Access Compliance Report

Public Rights-of-Way

(Curb Ramps)

Intersection ID: 49557	Main Street: STEEL_YARD_CT	Cross Street: WARREN_BURGESS_LN	Location: S
ADA ID: A8CE7534BF87	Ramp Type: BlendTrans1	Initial Pass/Fail: Fail	Overall Compliance: No
		Severity Score: 8.75

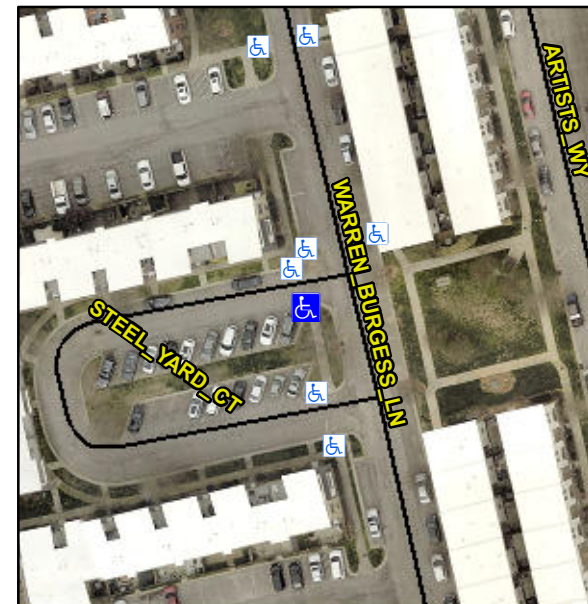
R304.5.1

Compliance	Description	Data	Compliance	Description	Data
N/A	Ramp Length (in)	48.0	Yes	BlendTrans Slope (%)	3.4
No	Ramp Width (in)	47.0	Yes	BlendTrans XSlope (%)	1.2
N/A	Flare Type LT	N/A	N/A	Flare Type RT	N/A
N/A	Flare Slope LT (%)	N/A	N/A	Flare Slope RT (%)	N/A
N/A	Flare Traversable LT?	N/A	N/A	Flare Traversable RT?	N/A
N/A	Landing Length (in)	N/A	N/A	DWS Provided?	N/A
N/A	Landing Width (in)	N/A	N/A	DWS Contrast?	N/A
N/A	Landing Slope (%)	N/A	N/A	DWS Length (in)	N/A
N/A	Landing X Slope (%)	N/A	N/A	DWS Full Width?	N/A
N/A	Landing Curb? (Y/N)	N/A	N/A	DWS Offset (in)	N/A
N/A	Shared Landing?	N/A			
N/A	Gutter Ponding?	N/A	N/A	Gutter Slope (%)	N/A
N/A	Gutter Lip Ht (in)	N/A	N/A	Gutter X Slope (%)	N/A
N/A	Painted X Walk1?	Yes	N/A	Painted X Walk2?	N/A
	X Walk 1 Direction	To NW		X Walk 2 Direction	N/A
	X Walk 1 Width (in)	49.0		X Walk 2 Width (in)	N/A
	X Walk 1 Slope (%)	1.0		X Walk 2 Slope (%)	N/A
	X Walk 1 X Slope (%)	1.4		X Walk 2 X Slope (%)	N/A

Remove & Replace Curb Ramp With Two New Directional Ramps or Equivalent.
